SUBJECT: Comments on the April 16, 2020 Draft Environmental Impact Report for proposed "Hollywood Center" project. State Clearinghouse Number SCH 2018051002.

SUBJECT: Comments on the scope and content on the NOP for the Environmental Impact Report for the "Hollywood Center" project.

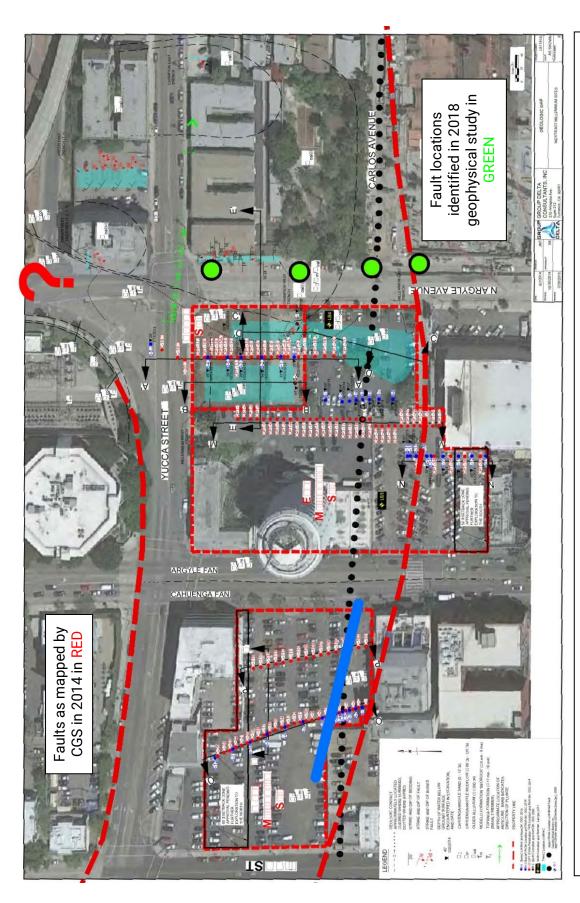
- 1. Fault traces depicted in CGS's 2014 Hollywood Fault Map do not appear in Appendix G-1's figures of the project site where locations of their subsurface investigations are presented. Therefore, we attach a figure showing both the location of traces as shown on the 2014 Hollywood Fault Map and the areas of investigation reported in Appendix G-1 (Figure 1). (DEIR Appendix G-2 shows the location of the fault trace at a lower level of resolution.) We note below that Figure 1 reflects new information indicating the active fault, which was not cleared by either the 2014 trench or the other investigative techniques reflected in Appendix G-1.

- 2. The 2020 USGS study, and other studies that post-date CGS's 2014 Hollywood Fault Map, strongly suggest an active strand of the fault crosses the project site. CGS considered the 2020 USGS study in light of other studies conducted after the 2014 Hollywood Fault Map. These studies are listed at the end of this letter and, for your convenience, are also available on CGS' FTP server (FTP Link). These studies, conducted east of the project site, postdate the studies included as Appendix G-1 to the DEIR, and are therefore new information of importance to public safety. These studies strongly support the presence of an active southern fault strand entering the eastern Hollywood Center property in the vicinity of the alley at Argyle, south of the

- 3. The fault trench excavated in 2014 did not clear the entire site of active faults. Based upon review of the information presented in Appendix G-1 of the DEIR, the GDC trench on the east property did not completely expose the base of the Holoceneage geologic section across the north-south extent of the site and therefore cannot be considered to exclude the presence of an active fault at or near where it is depicted in CGS's 2014 Hollywood Fault Map, or in the more recent studies mentioned above.

location of the zone of faulting from a CPT and boring transect from Ninyo & Moore reports. Orange rectangle inside the Apartment active faults from the CGS Hollywood Fault Evaluation Report, 2014. Green dots represent locations where the Hollywood Fault has project represents a zone of faulting from both CPT and core boring study by Group Delta. Blue line represents the steeply inclined been located based on 2018 geophysical studies by the USGS. Orange rectangle inside the Hollywood Courthouse represents the Figure 1. Air photo image of the Hollywood area of Los Angeles with annotation by CGS. Red dashed lines are surface traces of Hollywood fault where it was encountered in Group Delta CPT and borings at depth.

package with annotations by CGS. Turquoise shapes identify outline of approximate trench excavations at the ground surface. epresent locations where the Hollywood Fault has been located based on recent geophysical studies by the USGS. Blue line show core boring and Cone Penetration Test (CPT) locations across the site. Black dotted line is Group Delta's inferred fault Holocene materials across the entire length of the trench due to depth of excavation and benching style. Red and blue dots trace, located at depth. Red long dashed lines are surface locations of active fault traces from CGS FER 253. Green dots Frenches were excavated in vertical benches from the ground surface to selected depth. Excavation did not expose pre-**Figure 2.** Google Earth image of the project location. Figure from Group Delta Fault Study Reports, as included in DEIR represents the steeply inclined Hollywood fault where it was encountered in Group Delta borings at depth
